Titan Connect Installation Instructions Addendum 2023 Ford, UIS Equipped

These steps are to take occur in place of the CAN Connections section (Titan Connect Installation manual, page 21).

CAN CONNECTIONS (Location: inside cab, right-side, behind glove compartment)

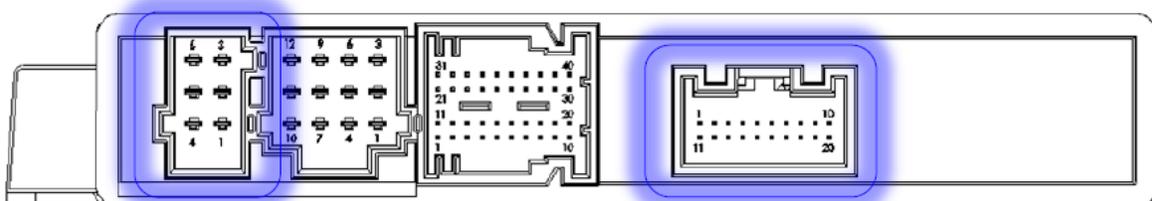
1. Route “CHASSIS CAN” wires into cab through firewall to UIS module located on the passenger’s side, behind glove compartment.
2. Disconnect both the black 20-way and blue 6-way connectors to ensure no power is being delivered to module.
3. On the black 20-way connector, locate the J1939 wired circuits 3 and 4.
4. Use high quality tap connector (example: posi-tap) to splice “CHASSIS CAN HIGH” wire into circuit 3; the green/blue CAN Positive wire.
5. Use high quality tap connector (example: posi-tap) to splice “CHASSIS CAN LOW” wire into circuit 4; the gray/blue CAN Negative wire.
6. Reconnect the Black 20-way, and Blue 6-way to the UIS module.

PROGRAM INSTALLATION

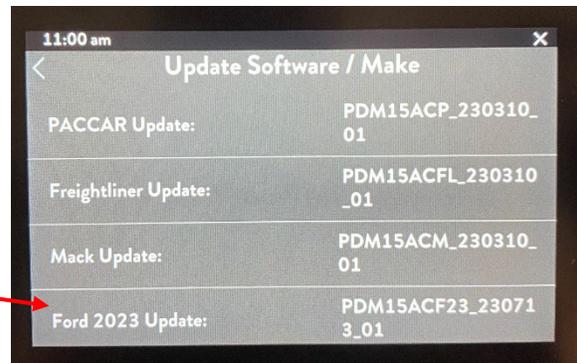
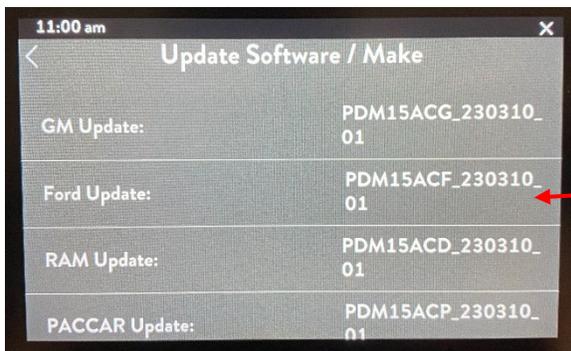
1. 2023 Ford chassis requires an updated Titan Connect program; AutocraneRemote_PV500_230714_01.pv1 is the file name. Earlier versions of the Titan Connect program will not provide full functionality with 2023 Ford chassis.
2. On the LCD screen, in the General menu, the Software Version should read AutocraneRemote_230714_01 once the correct program is installed.
3. Be advised, there are two Ford options in this version of the program. For this install, be sure to select the "Ford 2023 Update." "Ford Update" should be used for 2022 chassis and older.
4. Once the proper update is installed, the PDM Version should read PDM15ACF23_230713_01 in the PDM menu.
